S.S. PAPADOPULOS & ASSOCIATES, INC.
ENVIRONMENTAL & WATER-RESOURCE CONSULTANTS

Subject: **Approval with Modification of the 2017 Annual Report
Sparton Technology, Inc. - Former Coors Road Plant Remedial Program
EPA ID No. NND083212332
ST-18-002**

Figure 1 - Hydrograph of Monitoring Well MW-09

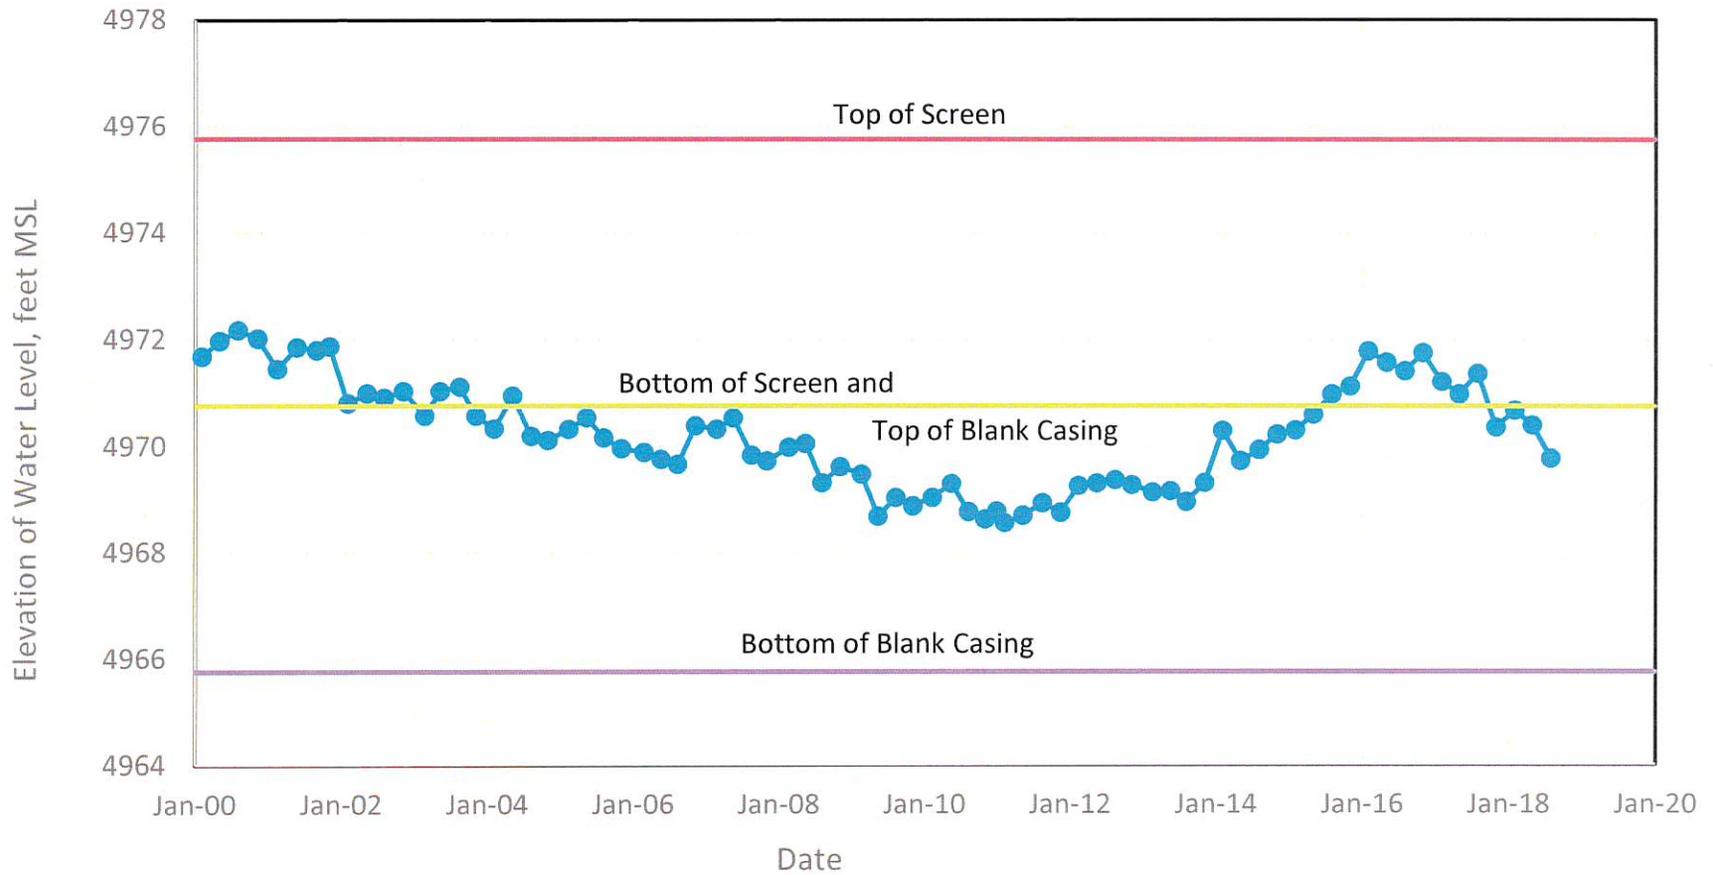
Reference is made to your letter of September 13, 2018 addressed to Mr. Ernesto Martinez of Sparton Technology, Inc. (Sparton) on the subject approval. Your letter points to Table 3.1 of the Annual Report, which noted that the water level in monitoring well MW-09 was below the bottom of the screen during the fourth quarter of 2017, and requests that we “describe how the sample was collected from this well and discuss whether the data generated from this sample are valid.” Your letter also requests that future Annual Reports provide “a table listing all wells and which includes corresponding descriptions of the purging and sampling methods used for each well (e.g., dedicated pump, bailer, submersible pump) and the sampling frequency (e.g., semi-annually, annually).” On behalf of Sparton, S.S. Papadopoulos & Associates, Inc. (SSP&A) is pleased to respond to these requests.

The 4th Quarter of 2017 was not the first time the water level in MW-09 was below the bottom of the screen. The well has 5 feet of screen with 5 feet of blank casing below the bottom of the screen, and the water-level in the well has been below the screen bottom and within the blank casing section for most of the time since the start of the current remedial operations, as indicated by the hydrograph of the well, presented in Figure 1. The blank casing does not have a bottom plug, and when the water level in the aquifer is below the bottom of the screen, groundwater flows in or out of the well through the open bottom of the blank casing. The hydrograph of the well (Figure 1), indicates that, besides the screened interval, the well is also connected to the aquifer through its bottom and that the water level in the well continues to respond to water-level changes in the aquifer even during periods when it is below the bottom of its screen. A comparison of the hydrograph of this well to the hydrograph of the nearby monitoring well MW-12 (see Figure 2), in which the water level has always been above the bottom of the screen, further supports the conclusion that MW-09 is connected to the aquifer through the bottom of the blank casing.

Water levels in the well are measured quarterly, and the water level in the well has time to equilibrate with the water level in the aquifer;² the well is sampled only during the fourth quarter, usually within two weeks or less after the water-level measurement, using the sampling procedures described above. Water-level measurements and samples from the well are, therefore, representative of the water level and water quality in the aquifer at the well location, even when the water level is below the bottom of the screen and are valid for use in the preparation of water-level and plume maps.
